PARKS BUILDING SUPPLY LASSEK RES. EWP FIRST

#24376 - Cedar Creek Modified For Lassek

POSTON-KATIE | 24376 ROOF

Input by: Richard Stokes Job Name: 21-6482 BEAM CALCULATIONS

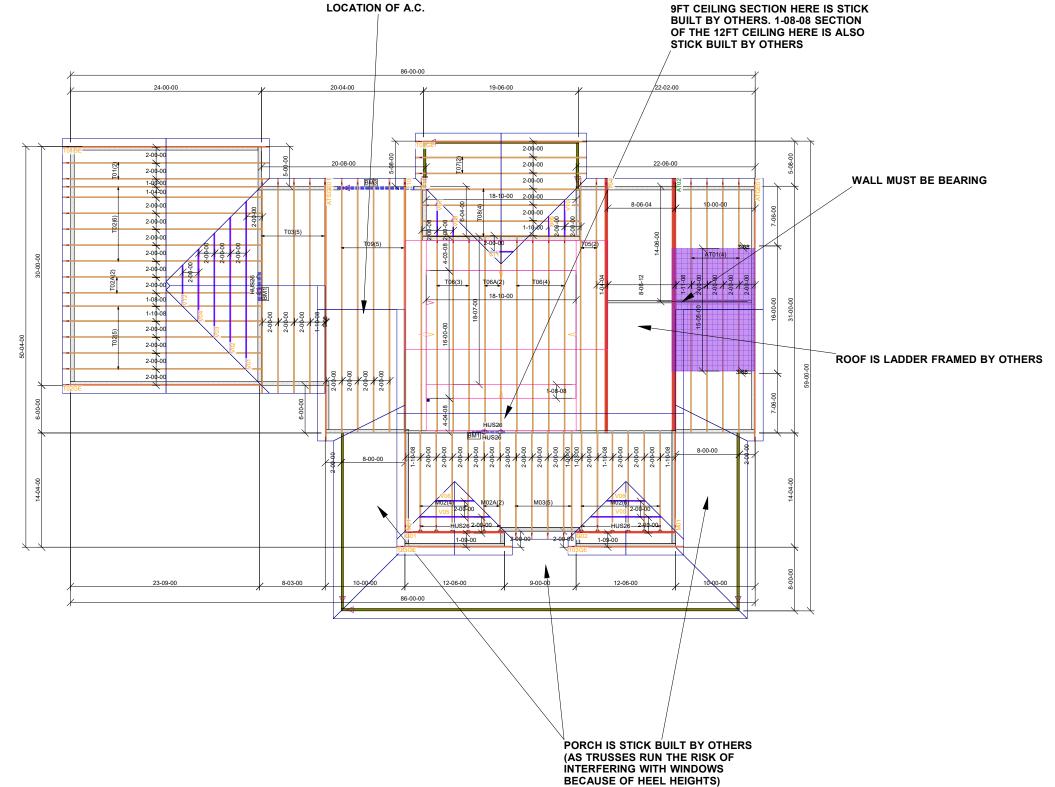
PLEASE VERIFY-

WILL DEPTH OF BM3 WORK(WILL IT BE IN THE WAY OF THE WINDOWS)

HEEL HEIGHTS WILL WORK (HEEL HEIGHTS HAD TO BE MORE THAN STANDARD TO GET ATTIC ROOF TRUSSES TO WORK)

OVERHANG LENGTH

PORCH IS STICK BUILT BY OTHERS (AS TRUSSES RUN THE RISK OF INTERFERING WITH WINDOWS BECAUSE OF HEEL HEIGHTS)

TRAY CEILING DIMENSIONS ARE CORRECT

ARE LOUVERS FALSE, IF NOT WHAT ARE THEIR DIMENSIONS

LOCATION AND DIMENSIONS OF PULL DOWNSTAIRS FOR A/C ABOVE IN GARAGE AND MAIN HOUSE.

IS LOCATION OF A.C. CORRECT
